JK Knit Composite Ltd

Tanima Composite

29 September 2013

Observations

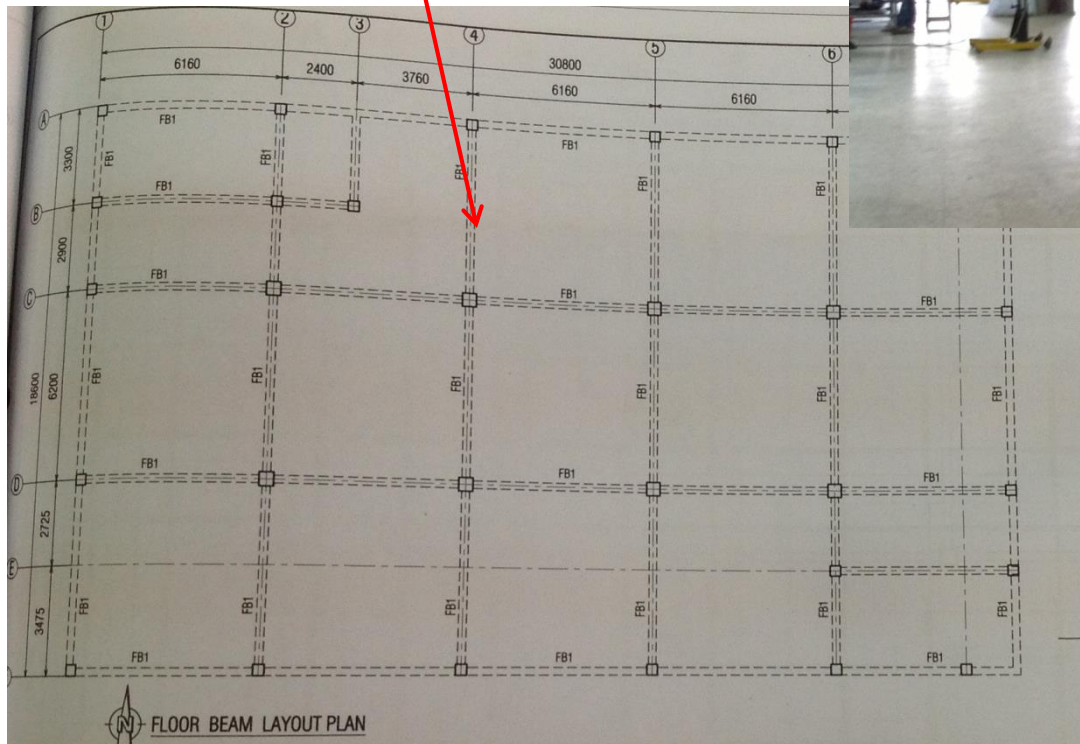
Structural drawings do not match as-built Building #1

As-builts indicate beam and slab construction with 500x500 internal columns

Structure is flat slab with column heads on 450x450 cols
